ENVIRONMENTAL REVIEW TEAM REPORT

ROLLWOOD PLANNED RESIDENTIAL DEVELOPMENT GUILFORD, CONNECTICUT

MARCH 1981

FIGURE 1. SIMPLIFIED SITE PLAN

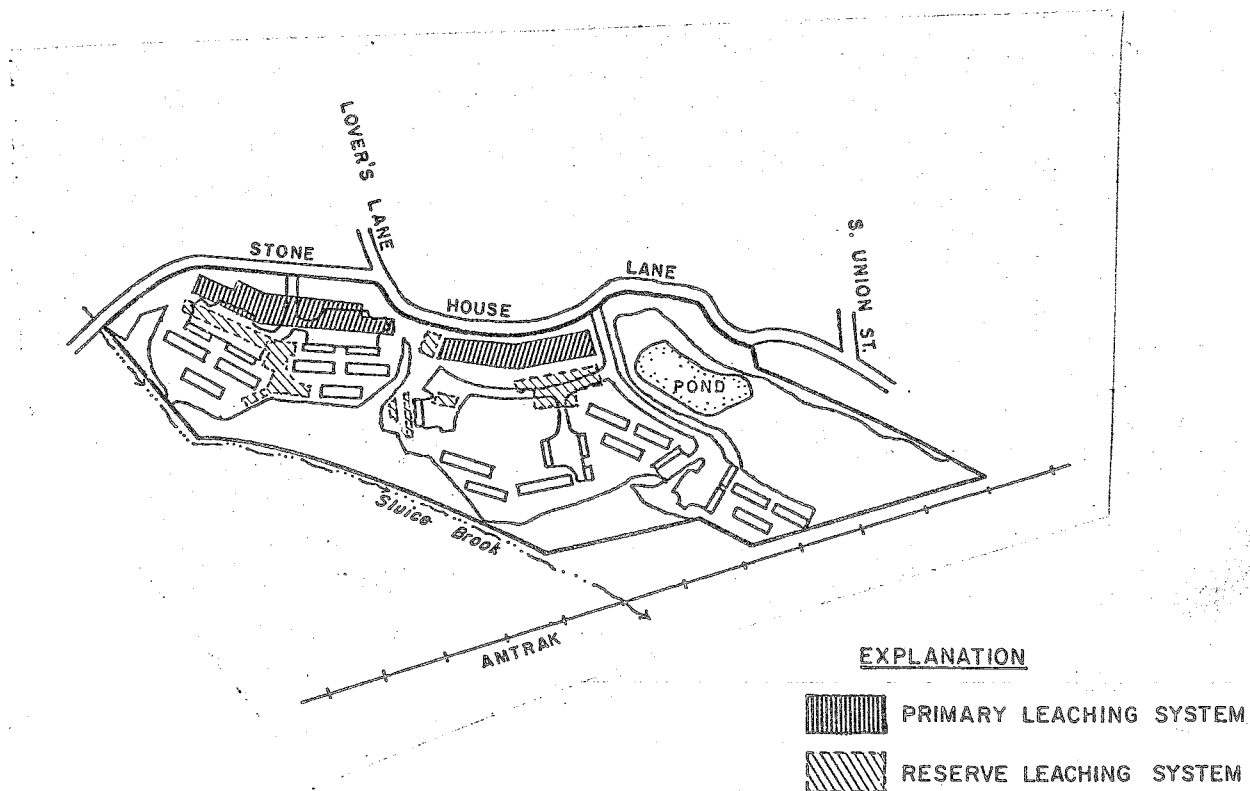
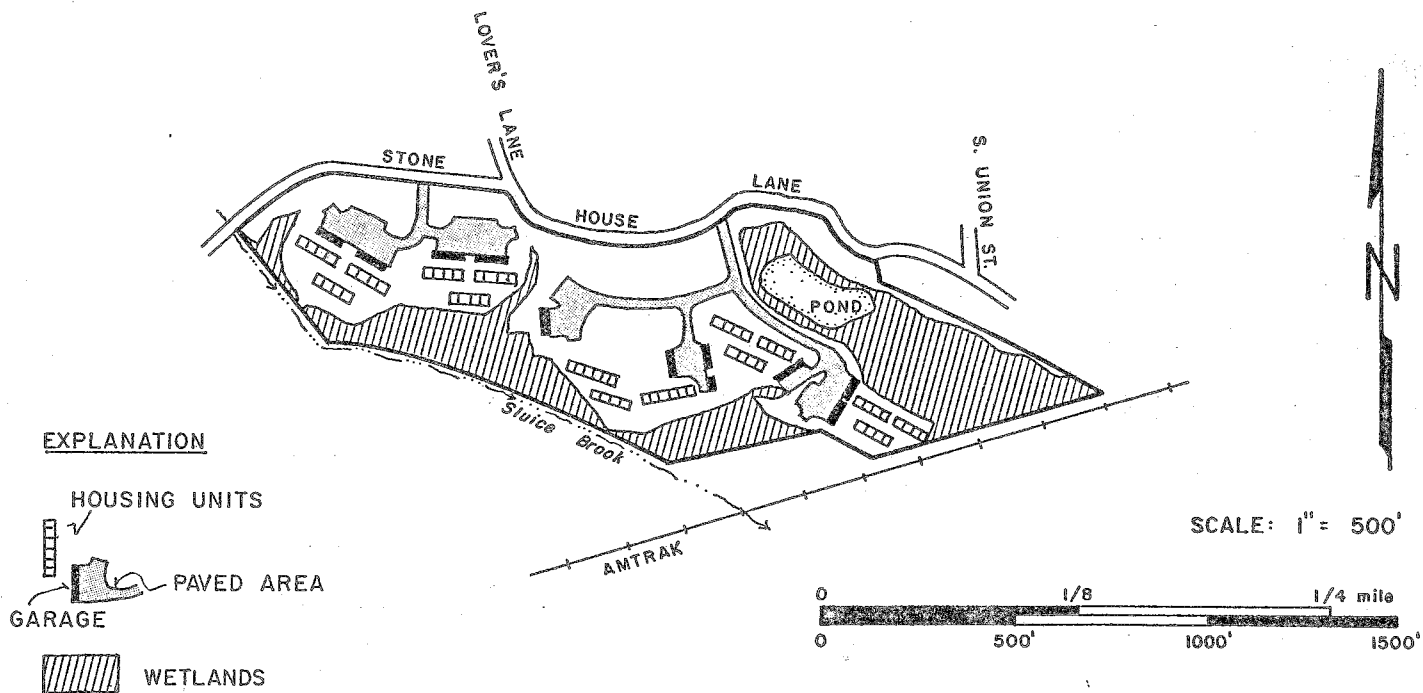
1. The proposed pond as described on the site plans extends into the tidal marsh area. Unless the pond is properly diked, it could be subject to tidal flooding in which case the water in the pond would be brackish (part salt and part fresh).

It should also be noted that steep side slopes excavated in the Westbrook and Ninigret soils (those soils in the area of the pond) tend to be unstable.

Consideration should be given to eliminating the pond from this proposal or else relocating the pond in a more suitable location (i.e. a non-tidal area).

FIGURE 5.
VEGETATION TYPE MAP

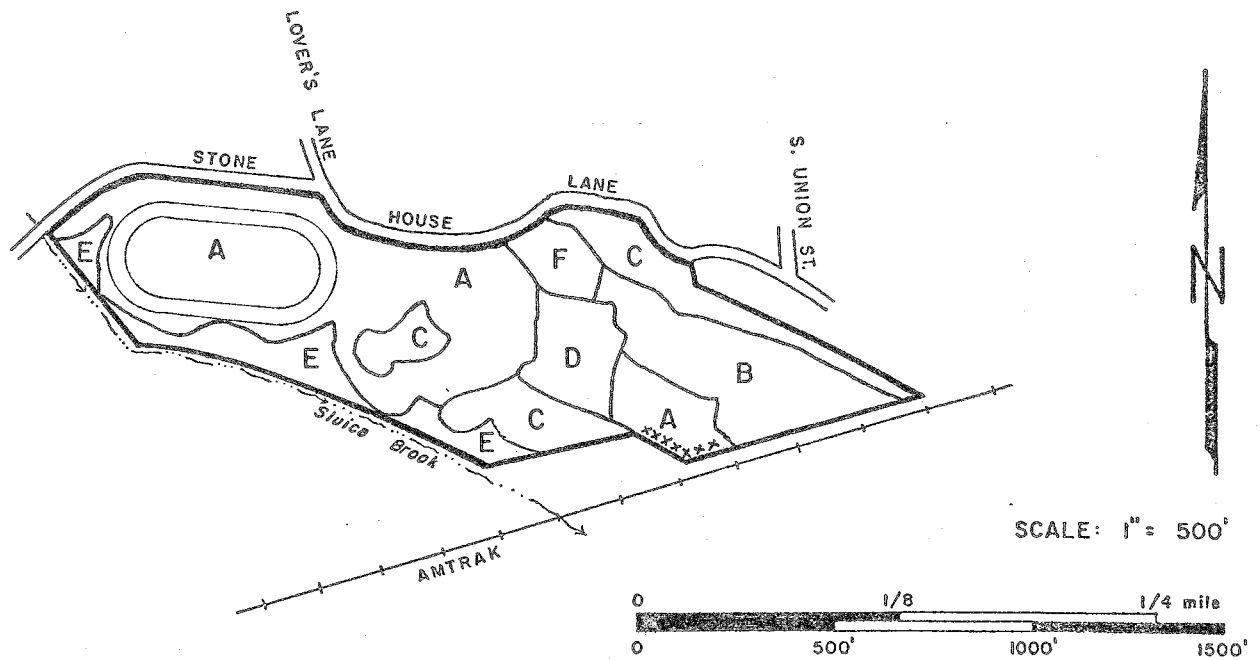
It would be desirable from an aesthetic stand point to retain as many of the trees in vegetation type C as possible (see Figure 5).

Development of an earthen berm between the proposed buildings and the railroad track, and planting that berm with evergreens, would help to reduce the impact of passing trains on future residents (see Figure 5).

It should be recognized that there are trees present in vegetation type C (mixed hardwoods) which have high aesthetic value. These trees, and perhaps the entire area of vegetation type C should be retained as is, with the possible exception of the removal of a few dead and severely damaged trees. These areas provide a natural barrier which will block to some extent the view of passing trains. These areas left almost as is will provide the future residents of this area with a small but natural and useable open space area.

The buildings which are proposed for the south eastern section of this parcel will be most impacted by the passing of the Amtrak trains. This impact can be reduced by mounding of soil and plantings designed to form a barrier between the proposed buildings and the railroad track (see Vegetation Type Map for berm and planting location). A solid earthen barrier constructed high enough to screen the passing trains from view, planted with a dense strip of salt tolerant evergreens would help to soften the trains impact on residents. White spruce, eastern red cedar and yews should be considered for this planting. These species have dense evergreen foliage and are somewhat tolerant of salt spray.

FIGURE 6.
COASTAL RESOURCES

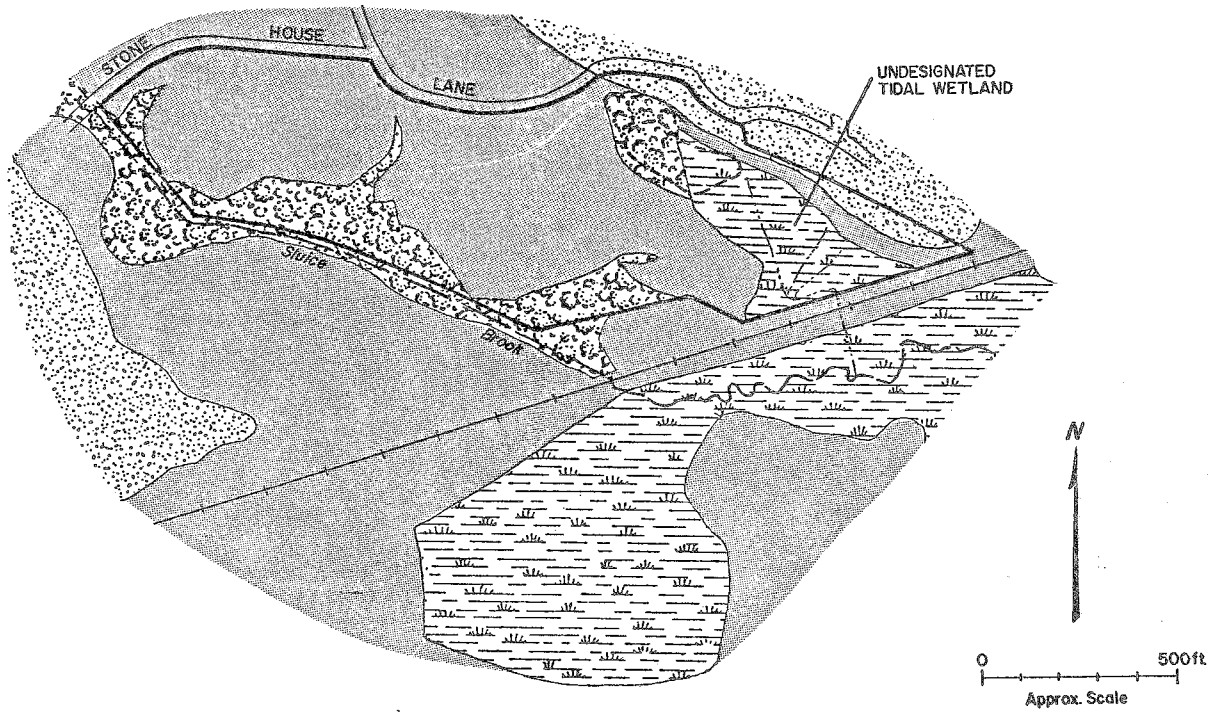
The applicant has correctly identified the coastal resources on the site, including the coastal hazard area, and freshwater wetlands and watercourses. Additionally, the undesignated tidal wetland should be depicted on this site (see Figure 6) rather than incorporating it into the freshwater wetlands category. It is difficult to ascertain, on the basis of the project maps, whether or not shorelands bordering the tidal wetland to the east are inside or outside of the property or both. In any event, the project plans should be modified to depict the coastal resources adjacent to the project site, especially the downstream tidal wetlands.

The undesignated tidal wetland, mapped as a tidal wetland in Figure 6, is not a state regulated tidal wetland for it does not appear on the official map of state designated tidal wetland maps. However, undesignated tidal wetlands can be regulated by the local inland wetland commission as an inland wetland. Section 22a-38 of the Connecticut General Statutes defines an inland wetland as "land, including submerged land, not regulated pursuant to sections 22a-28 to 22a-35 (i.e. 'Tidal Wetland' Act), inclusive, which consists of any of the soil types designated as poorly drained, very poorly drained..." Therefore, since this is an unregulated tidal wetland and is composed of a very poorly drained soil type, the Westbrook series, it constitutes a wetland to be regulated by the inland wetland commission. Further, under the provisions of the Coastal Zone Management Act, the Guilford Planning and Zoning Commission could apply the tidal wetland policies (see following paragraph) to such

an undesignated tidal wetland in reviewing the coastal site plan for the proposed project. In addition, given that the wetland does appear to satisfy the requirements for state designation as a tidal wetland, the town could also request that this wetland be regulated by the D.E.P. Water Resources Unit under the tidal wetland statutes.
